Comparison of Vehicle Efficiency Technology Attributes and Synergy Estimates

Subcontract Report
NREL/SR-6A20-47806
February 2011

For these tasks, the Energy and Environmental Analysis (EEA) division of ICF International (ICF) examined each technology and technology package in the Draft TSD and assessed their costs and performance potential based on U.S. Department of Energy (DOE) program assessments. ICF also assessed the technologies' other relevant attributes based on data from actual production vehicles and from recently published technical articles in engineering journals. ICF examined technology synergy issues through an ICF in-house model that uses a discrete parameter approach.

Figure 3-1. Hitachi/Nissan CVVL mechanical implementation

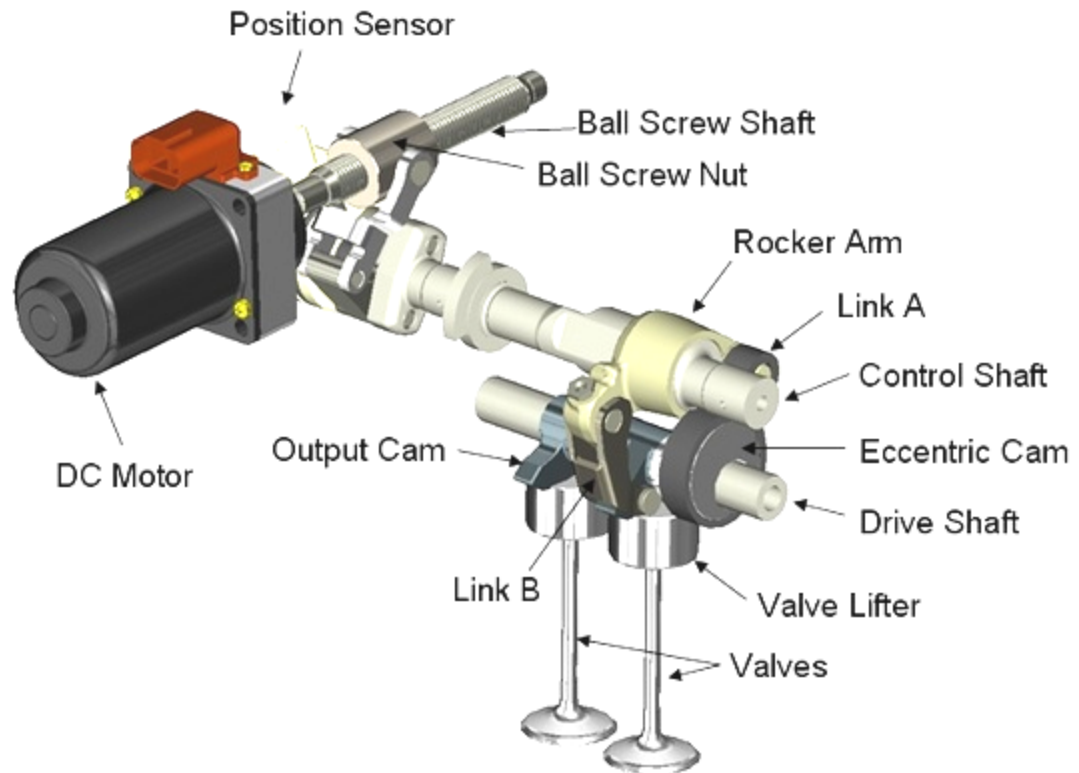
ICF believes the benefits of continuously variable valve lift (CVVL) should be higher than those of cylinder deactivation because the CVVL system covers a wider range of revolutions per minute (rpm) and load when pumping loss can be reduced relative to

cylinder deactivation, but the estimated benefit in the TSD is lower for CVVL at only 3% to 4%. The benefits are also substantially lower than the benefits claimed by BMW and Nissan (who have such systems on the market) based on measured data. Existing CVVL systems are usually designed to achieve a combination of both lift and valve opening duration change via an intermediate lever mechanism working in conjunction with cam phasers. This approach, also known as “intake throttling,” allows elimination of the conventional throttle unit because the engine air flow can be controlled through real-time adjustment of the inlet valve lift and opening times.

Our estimates show that CVVL, when VVT contribution is subtracted, yields about 8% fuel economy benefit. In fact, the estimate appears to be on conservative side because Honda’s AVTEC solution appears to yield higher benefit, if other advantages of fully flexible valve lift and timing control such as idle speed reduction and improved torque are fully exploited.

Figure 3-2. LS 460 and LS430 fuel economy comparison—contribution of various engine technologies

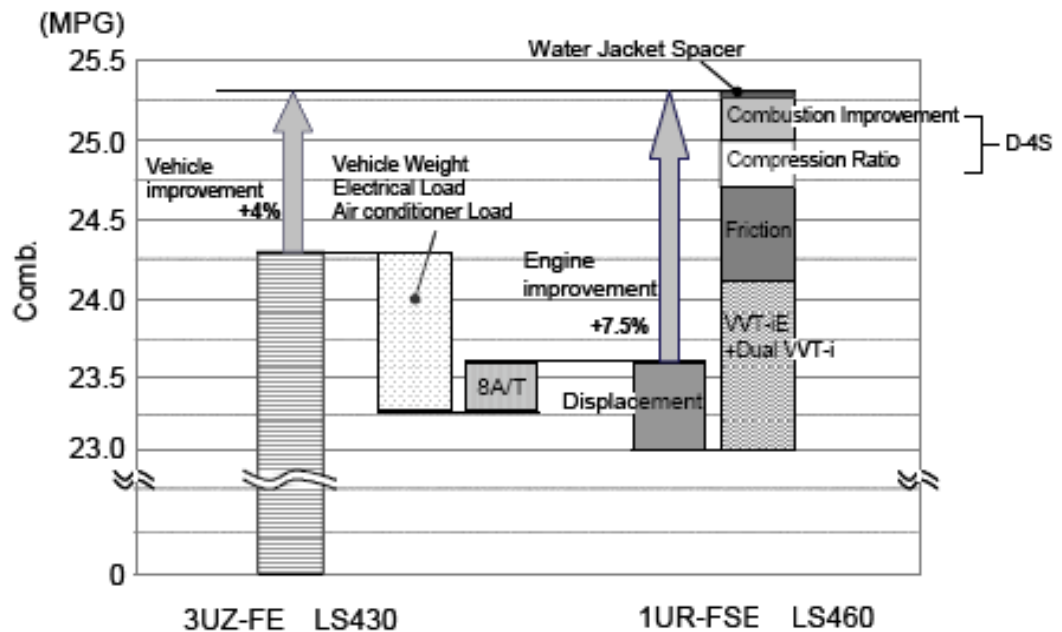
The TSD reviews estimates for incorporating GDI that range from 1% to 5.8%, but somewhat arbitrarily picks a range of 2% to 3% as “appropriate.” The main mechanism that allows GDI to improve fuel economy, however, is the increase in compression ratio (CR) caused by the cooling effect of fuel spray evaporation in the cylinder. Hence, variability in GDI benefit estimates can be traced to the CR increase assumptions in the studies cited. In addition, other studies have also shown that some GDI benefits arise from combustion improvements facilitated by GDI. Stoichiometric naturally aspirated GDI engines are being used by few OEMs in the United States. Toyota has introduced this technology in the dual injection 3.5L V6 and 4.6L V8 engines used in the Lexus offerings. Volkswagen and Audi are configuring more of their vehicles to adopt the technology labeled FSI (fuel straight injection), and General Motors (GM) has introduced GDI on the 3.0L and 3.6L V6, with additional introductions planned for MY 2010.

The majority of mass market vehicles in the United States in 2008/2009 with PFI engines had CR levels of 9.5 to 10.0, and luxury models certified for premium fuel had CR levels of 10.5 to 11. It appears the GDI can increase CR levels by 2 points to the 11.5–12 range in mass market cars and to 12.5 for luxury cars by 2016. Even in 2009, all Audi GDI V6 engines had a CR of 12.5. GM’s first DI engine, the 3.6L V6, had a CR of 11.3, but the newer 3L introduced for MY 2010 has a CR of 11.7. ICF agrees that if the CR improvement is only 1 to 1.2 points, the fuel economy benefit range in the TSD is reasonable, but it appears that CR will increase by 2 points by 2016 and a benefit range of 3.5% to 4.5% is more appropriate.

Figure 4-1. Comparison of the difference between Ricardo and EEA fuel economy simulation results

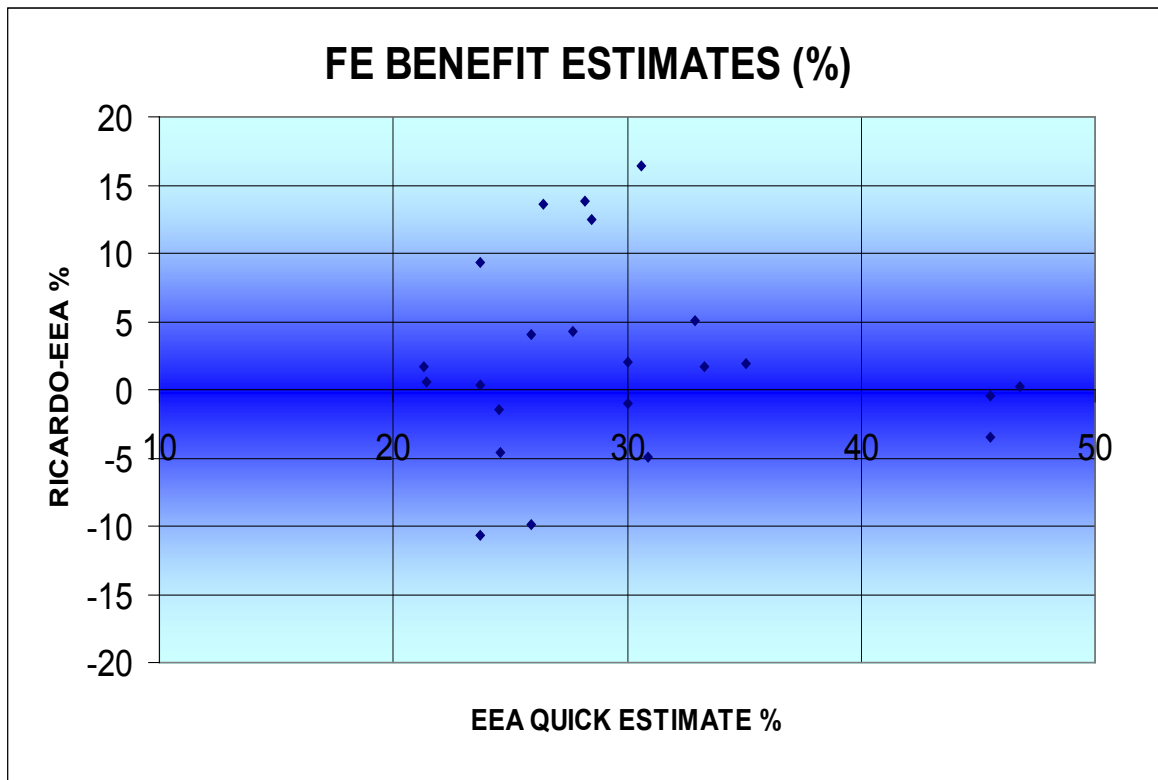
In 16 of the 23 cases, the Ricardo estimate is within 5% of the quick estimate. In two cases, the Ricardo estimates were more than 10% lower relative to the quick estimates. In five cases, the Ricardo estimates were 10% (or more) higher than the quick estimate. Note that the difference implies that the benefits are larger than the simple sum of individual technology benefits and that technology synergies are positive. We also examined the technology packages in the two “low” and five “high” outliers. Both low outliers had technology packages with a continuously variable transmission (CVT) as one of the technologies. The five high outliers did not feature any major technology improvement in common.
